Steel Twin Screw Steamer No.764 proposed to be built by the Stabilimento Tecnico Triestino for the Lloyd Sabaudo with a view to class 100A1 With freeboard.

Dimensions:- 625 x 78 x 39.5 to E dk (C.S.S. Upper dk)
67 to B dk. (top strength dk amidships)

Plans of midship section, profile and decks are submitted by the Trieste Surveyors, a preliminary proposal having been considered on the 8th March last, when the Surveyors were informed as to the principal alterations which would be necessary on account of the increased breadth proposed.

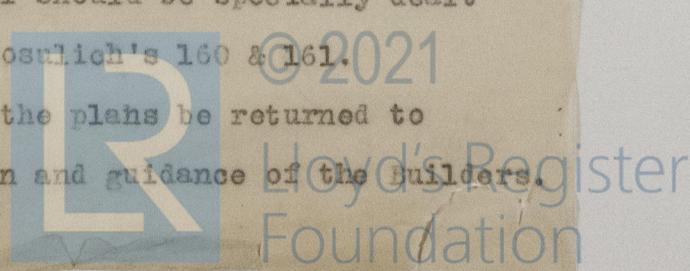
In the case of the "CONTE BIANCAMANO" the double bottom was 4" deeper than required by the Rules, but the centre girder and margin were correspondingly reduced in thickness. A continuous side girder (instead of an intercostal girder) was fitted each side of the double bottom but the centre strake of inner bottom plating was reduced 8" in width, the double bottom being fully equal to the Rule requirements.

In the present ship it is further proposed to fit solid floors to alternate frames (as permitted by the Rules) except in the machinery space and forward of the half length, whereas in the "CONTE BIANCAMANO" solid floors were fitted to every frame. The "3" strake of side plating, which is stated to have cracked at the corners of the sidelights, is 11 m.m. in thickness in both ships.

Although the scantlings and arrangements as submitted would comply with the Rule requirements and the practice of the Committee, yet, in view of the statement contained in the Builders' letter, it is submitted that before the plans of this ship can be finally approved it will be necessary for Mr. Turnbull to report fully on the defects which have been stated to have been found in the "CONTE BIANCAMANO".
